LPE-200 APPLICATION NOTE

DS101283V1 LCD DISPLAY

The referenced display is used on the ROA1172318 CIRCUIT BOARD, FLEX ASSEMBLY.

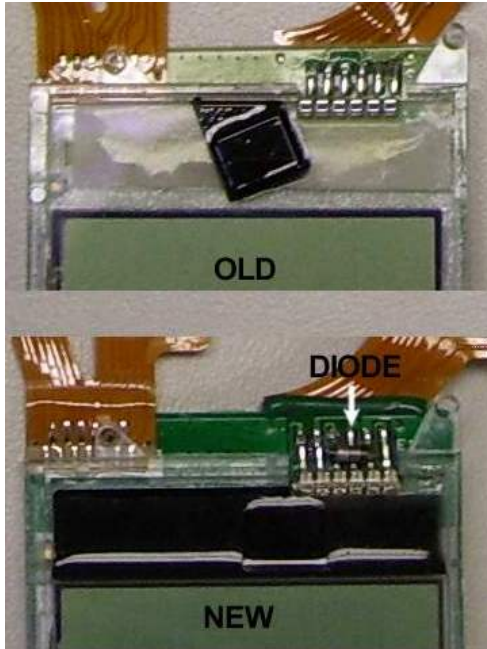
There are two versions of the LCD display.
The DS101283V1 is the latest p/n and requires the presence of a diode for this display to work.

The diode, if present, is soldered across the LCD Connection pins.

**Note: if the diode is not present the
Display will work on the bench but
Will fade at cold temperatures.**

If the customer has the diode already present on the ROA1172318 Flex Assembly only the DS101283V1 LCD Display is required to replace a defective display.

If there is no diode installed on the connector pins of The display the customer will need SPK-0120 which Includes the DS101283V1 LCD, the diode p/n A4036887P58 and other parts and instructions.
